***VILLAGE LANE SHOPPING CENTER  
PARKING LOT ADDITION***

# REVIEW COMMENTS

FILE #SPR-96-183

## RESPONSE TO COMMENTS

PSCO Lighting Design  
 Project:  
 Village Lane  
 Grand Junction  
 Date: August 29, 1996

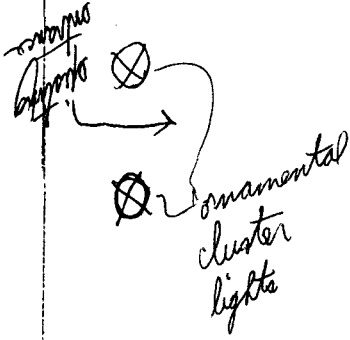
*How does it affect neighbors? Light screening needed?*

Not allowable

1. Parking lot lighting has been included on the revised plans. The proposal is for three overhead wired, cobra head style, lights to be placed by Public Service Company. As shown on the plans, there will be two lights along the southern boundary with one light placed in the approximate middle area of the northern parking lot boundary. A luminescence plot has been performed by Public Service Company and is included with the response. City of Grand Junction lighting standards are met with these three lights.

FILE NO. C:\MCCULLOUGH\WELLAND.DWG	
<b>VILLAGE LANE LANDSCAPE PLAN</b>	
PARKING LOT AT NORTH AVENUE AND MELODY LANE	
DATE	DATE
BY: JLC	BY: JLC
CHKD: JLC	CHKD: JLC
DATE: 7/24/98	REV: 3/2/98
SHEET 1	OF 1

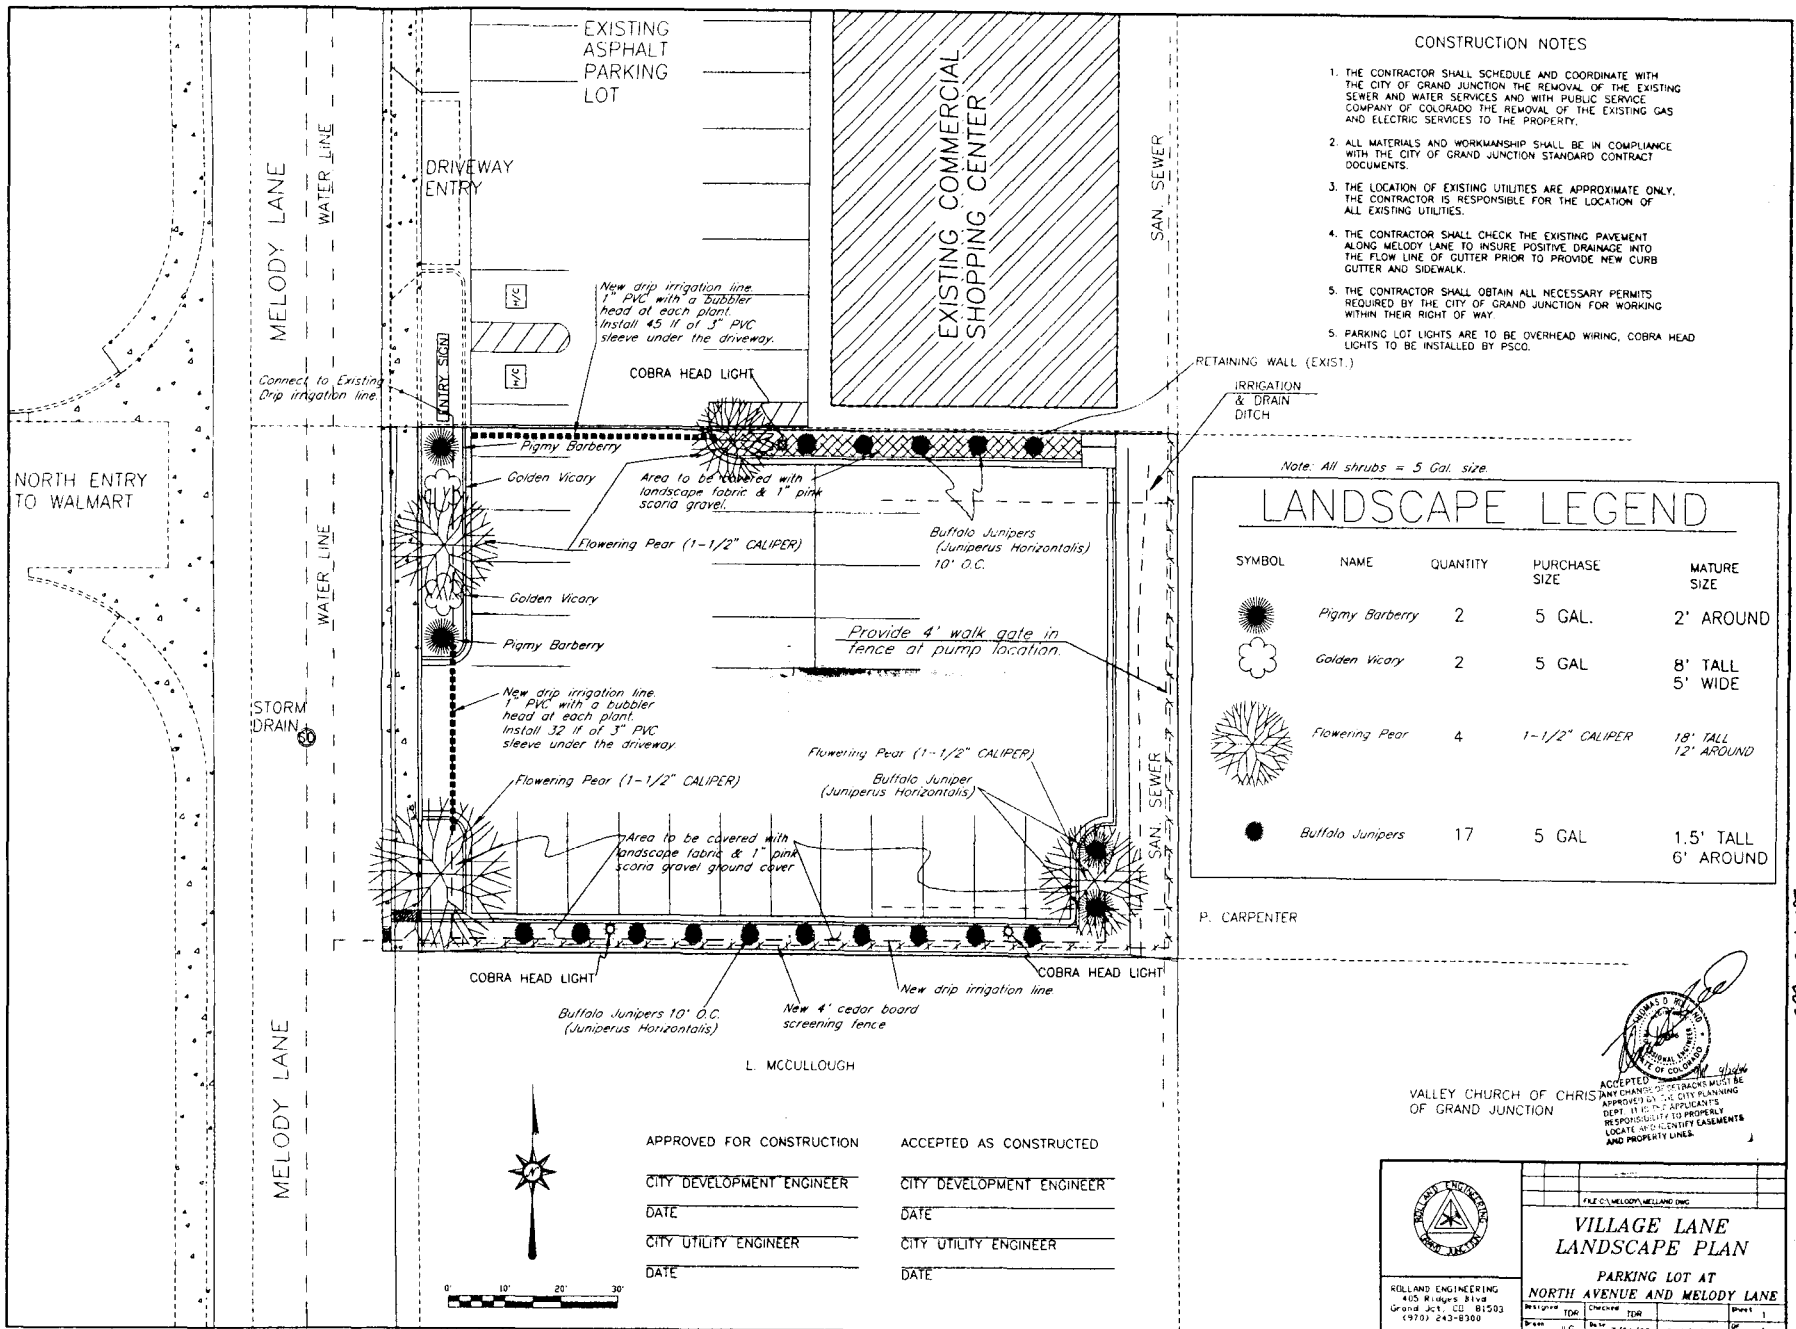
1. Need a lighting plan.
2. Plan needs a landscape legend indicating plant names, quantities, purchase sizes, mature size, types of soil, etc.
3. Explain why the plan does not show landscaping on the north and east sides of the parking lot. The Development Code requires it unless there are circumstances that prevent landscaping those areas.
4. Consider placing parking on the north and east sides of the parking lot instead of the north central area. This may create more spaces.
5. The south side of the parking lot would benefit from a tree placed in an island in the center. The Development Code requires a tree every 40 feet on the perimeter of a parking lot.
6. Be sure and call so we can discuss the above items before redrawing the site plan.

*Plan shows a shrub. Correct*

2. A landscape legend with the requested information has been added to the plan.
3. Mike Pelletier, Tom Rolland, and Trevor Brown held a meeting on 8/28/96 to discuss review comments. Additional plant landscaping has been added to the northern edge of the lot. The eastern edge will remain as shown with a fence being constructed between the parking lot and the irrigation ditch along the eastern boundary.

4. After discussion with Mike Pelletier, the parking lot spaces will remain as shown on the plan.
5. A tree has been placed at the west end of the north edge along the building in place of an additional tree along the southern border per the meeting on 8/28/96 with Mike Pelletier.

**VILLAGE LANE  
 PARKING LOT  
 GRADING AND DRAINAGE PLAN**

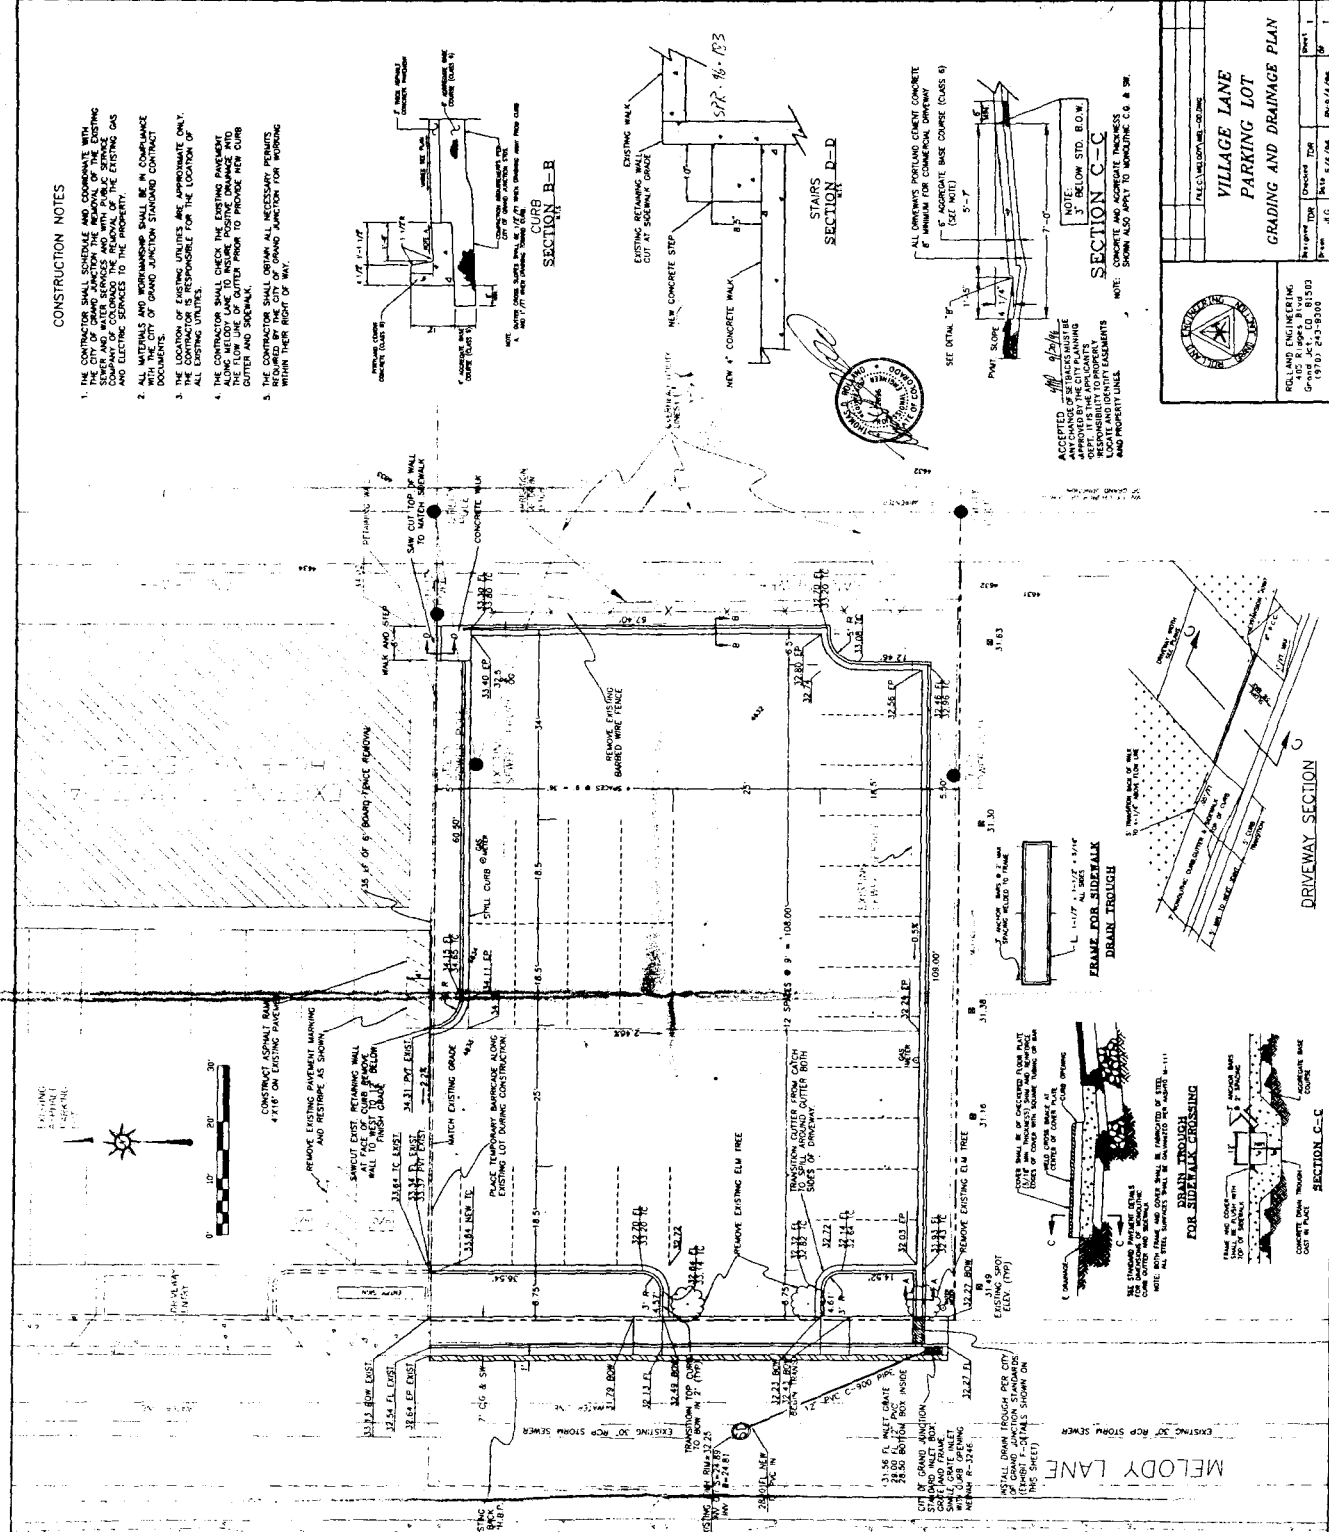
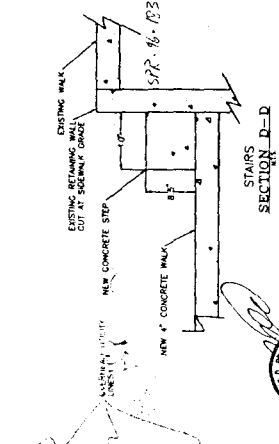
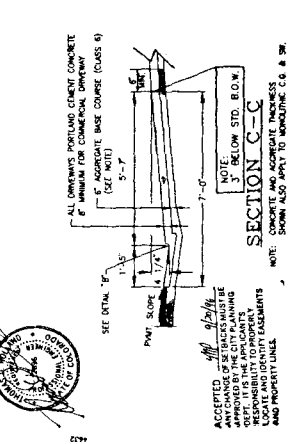
1. A permit from the City Engineer's office must be obtained by the contractor prior to construction of curb, gutter, sidewalk.
2. Credit is allowed for the drainage fee for the installation of the inlet and pipe in Melody Lane. No drainage fee will be charged.
3. Clarify on the plan for the sidewalk that a drain trough with the plate steel cover will be provided in accordance with Exhibit F of the City Standard Drawings.
4. TCP credit for the street improvements is allowed. Not TCP will be charged.

1. A permit will be obtained from the City Engineer's office prior to the contractor constructing any curb, gutter, or sidewalk.
2. Comment regarding no drainage fee noted.
3. Plan has been revised to reflect a drain trough with steel plate cover in accordance with Exhibit F of the City Standard Drawings.
4. Comment noted about no charge for TCP.
